## ASSESSMENT REPORT

### ENFIELD INTERMODAL LOGISTICS CENTRE MP 05\_0147 MOD 12

This report is an assessment of a request to modify the Project Approval for an Intermodal Logistics Centre at Cosgrove Road, Strathfield South.

**Figure 3 - Proposed additional sidings and extension to admin building.**

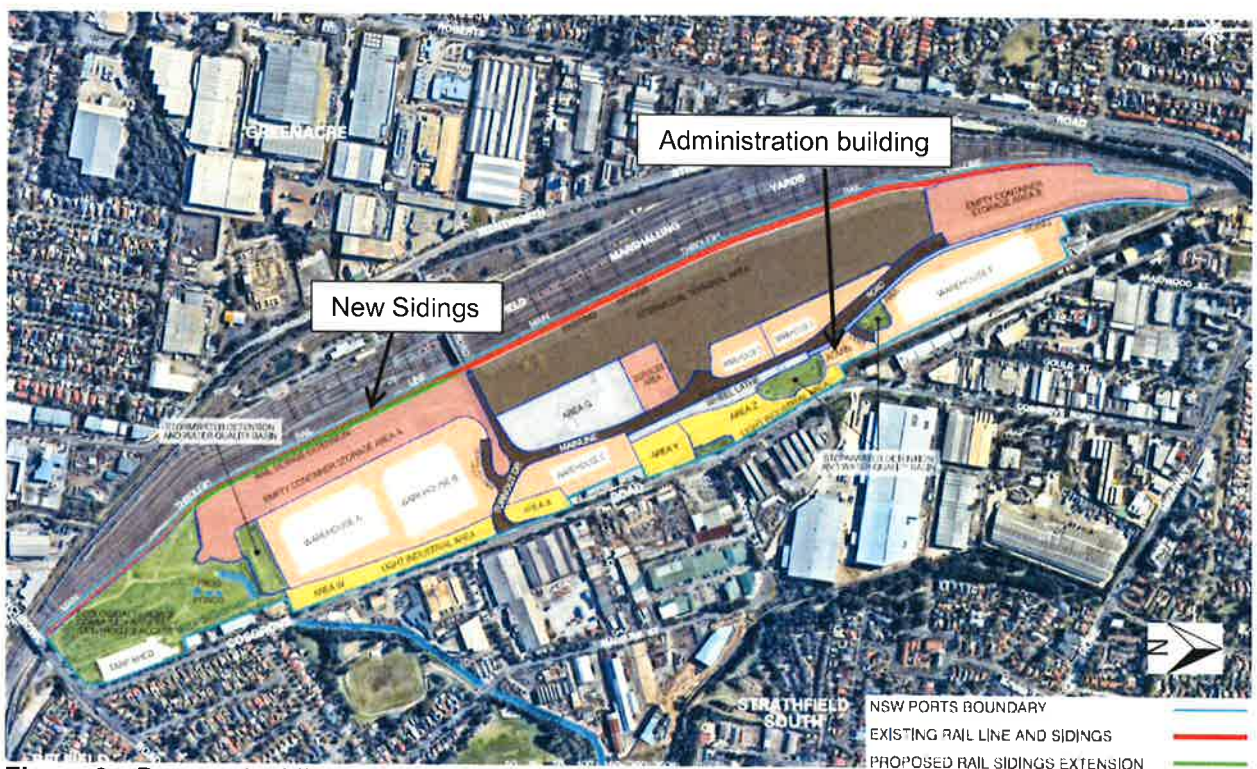
**Strathfield Council** did not object to the proposed modification, but raised concerns including:

- the extent of cumulative changes on the site result in a development that may not be substantially the same as the approved development;
- background studies, such as acoustic and traffic reports need to be updated;
- the Empty Container storage Area A should not be converted to an operational area;
- potential acoustic impacts; and
- potential light spill impacts.

<b>Issue</b>	<b>Consideration</b>	<b>Recommendation</b>
<i>Office extension</i>	<ul style="list-style-type: none"> <li>The proposal seeks approval to extend an existing administration office located adjacent to the main entry to the intermodal terminal area by: <ul style="list-style-type: none"> <li>erecting a second storey to the existing office building; and</li> <li>adding a third office space adjacent to the existing building.</li> </ul> </li> <li>This will increase the total office floor space from 200 sq.m to approximately 450 sq.m.</li> <li>The Department considers there would be minimal visual impacts associated with the proposal as the new office would be consistent with the height, bulk, scale and appearance of existing and approved development on the site.</li> <li>Further, there would be no adverse amenity impacts as the office would be located centrally within the site, adjoining other industrial development associated with the ILC.</li> <li>The Department is therefore satisfied the proposed office extension is acceptable as it is consistent with the industrial character of the site and would not result in any adverse amenity impacts.</li> </ul>	No additional conditions or amendments necessary.

<b>Traffic Access</b>	<ul style="list-style-type: none"> <li>The proposal seeks approval to extend the rail way sidings to improve the operational efficiency of the Enfield intermodal terminal, which has an overall strategic aim of reducing truck movements on Sydney's roads.</li> <li>The extended rail sidings would not affect the approved operational maximum throughput of 300,000 TEUs per annum and therefore would not affect traffic movements previously assessed for the Enfield ILC.</li> <li>While the additional office floor space would accommodate 10 to 15 additional staff, the Proponent advises the total number of staff would be consistent with the number of employees considered in the original traffic impact assessment.</li> <li>The Department is therefore satisfied the proposed modification would not result in any material traffic impacts beyond those already assessed and approved. As such, the Department is satisfied an updated traffic study is not required.</li> <li>The Department is also satisfied that the site has sufficient capacity to accommodate car parking on site.</li> </ul>	No additional conditions or amendments necessary.

<b>Light Spill</b>	<ul style="list-style-type: none"> <li>Strathfield Council raised concern about the potential impact of light spill on nearby residences during construction and operations of the intermodal logistics centre.</li> <li>The Department notes that while some lighting may be used during construction and the ongoing operation, the surrounding residents (east) are located more than 150m away from the location of the extended sidings.</li> <li>The Department also notes existing conditions require all external lighting to be screened and directed so not to create a nuisance to neighbours.</li> <li>The Department is therefore satisfied the modification would not result in adverse light spill impacts.</li> </ul>	No additional conditions or amendments necessary.
<b>Land Use</b>	<ul style="list-style-type: none"> <li>Strathfield Council raised a concern that the land adjacent to the new rail sidings should not be used for ILC operations such as container loading/unloading, and should be used as an empty container storage area as per the existing approval.</li> </ul>	No additional conditions or amendments necessary.

<i>Issue</i>	<i>Consideration</i>	<i>Recommendation</i>
	<ul style="list-style-type: none"> <li>The Proponent's RTS confirmed no change is proposed to the use of the site, other than a small reduction in the size of the empty container storage area to enable the rail siding to be extended.</li> </ul>
